PJM Interconnection, L.L.C.  
Docket No. ER20-1300-000

Reference: First Revised Service Agreement No. 4114

*Re: PJM Interconnection, L.L.C., Docket No. ER20-1300-000  
First Revised ISA, SA No. 4114; Queue No. AC2-016*

## SINGLE-LINE DIAGRAM

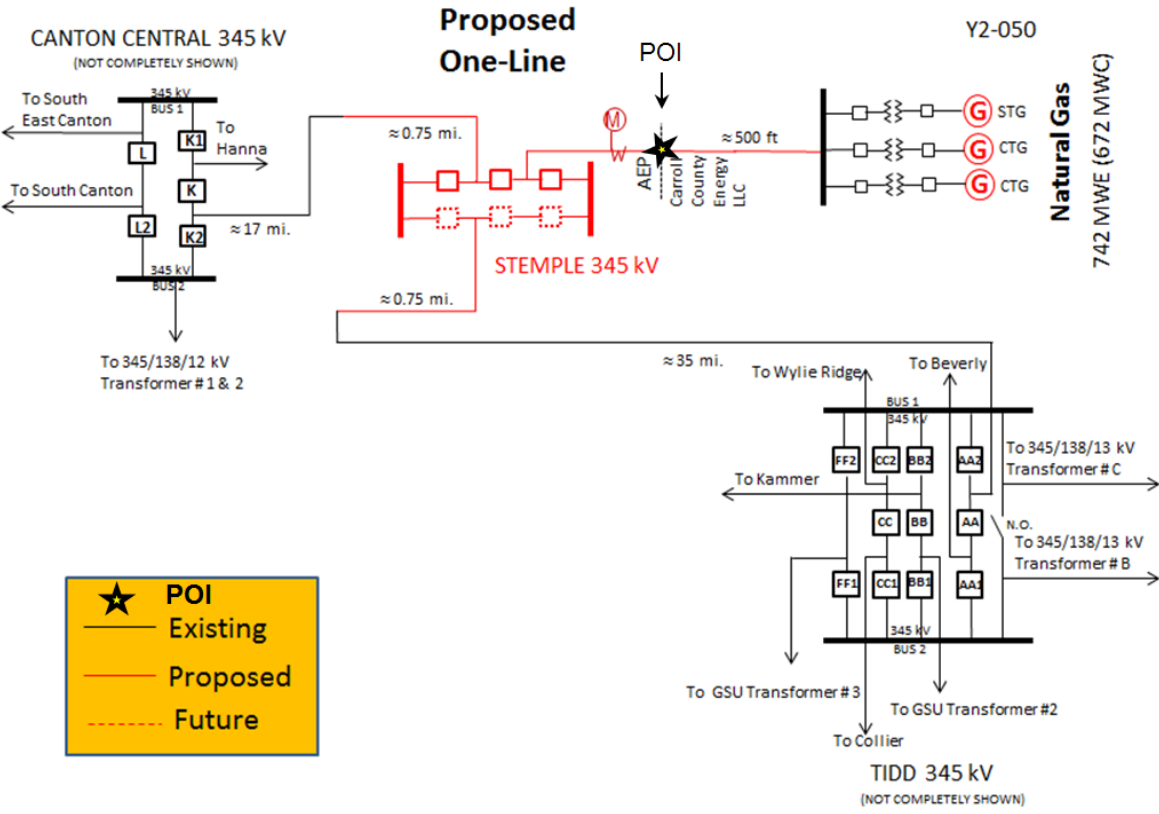
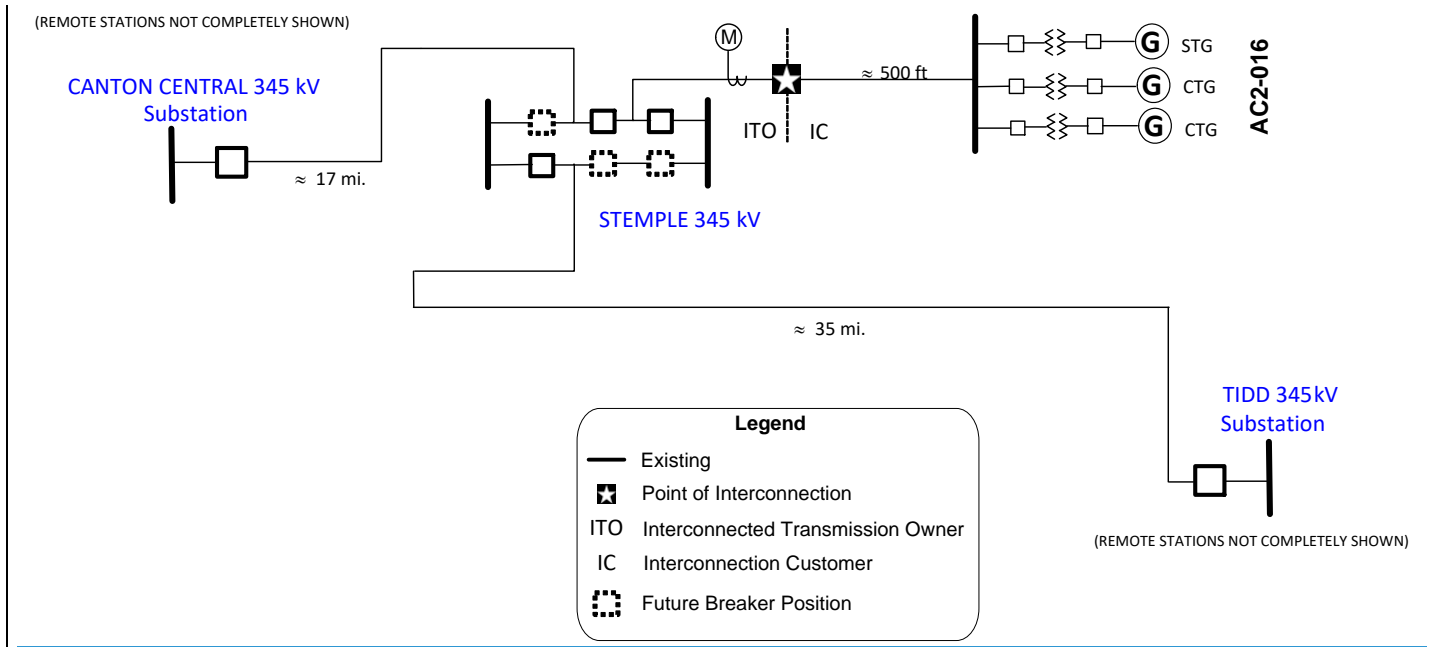
Third, there are additional miscellaneous changes. Schedule A has been updated to remove the image of the Customer Facility site plan because it is not required for existing facilities. Schedule B includes an updated single-line diagram of the Interconnection Facilities. Schedule C includes an updated list of metering equipment. Schedule D has been updated to reflect the fact that it is no longer applicable to the Carroll ISA. The heading of Schedule H has been revised, and Schedule I has been added to the ISA. The references to the prior ISA have been updated in section 1.0 and the execution dates on the ISA's execution page have been changed to reflect the execution date of the Carroll ISA. Changes have also been made throughout the Carroll ISA, including appendices, to conform its terms and conditions to the ISA Form in effect as of February 13, 2020, the effective date of the Carroll ISA.

The Point of Interconnection (“POI”) will be on the first structure outside of AEP’s ~~new~~ Stemple station leading to the Customer Facility, with AEP owning Stemple station and the first span of conductors required to interconnect the Customer Facility, and Interconnection Customer owning all structures and remaining conductors to the Interconnection Customer’s generation station.
